Service Bulletin

Bulletin No.: 17-NA-151

Subject: Outside Noise Heard from Back of Cab

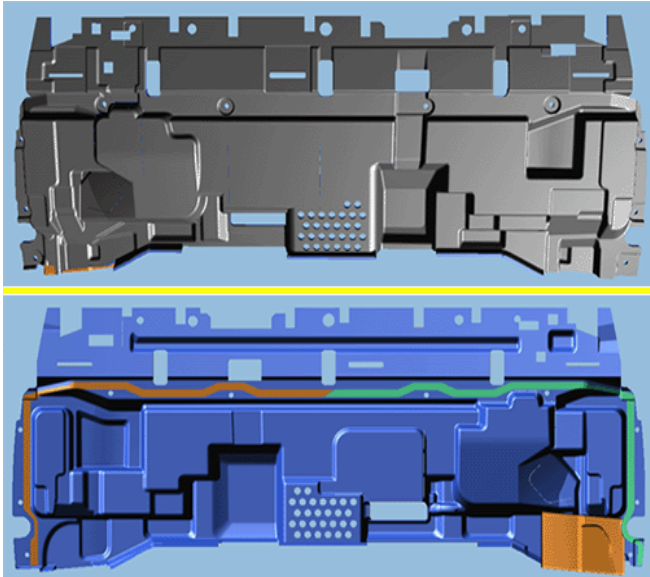
Involved Region or Country	North America and N.A. Export Regions
Condition	Some customers may comment on hearing outside noise from the back of vehicle cab.
Cause	The cause of the condition may be a window of vehicle builds involved a cab insulator supplier change in which a 2D design was installed which didn't comply with previous 3D insulator acoustic performance.
Correction	Inspect the vehicle's rear cab insulator to verify which design it currently has and continue to the repair recommendation in the Service Procedure below.

Inspect the rear cab insulator to verify which insulator the vehicle contains:

- If the vehicle contains the **3D** insulator shown in the front and rear view examples above, **DO NOT** replace the insulator. No further repairs are recommended.

- If the vehicle contains the **2D** insulator shown in the front and rear view examples above, acoustic performance can be gained by replacing the insulator with the **3D** design. Replace the body rear panel insulator. Refer to *Body Rear Panel Insulator Replacement* in SI.
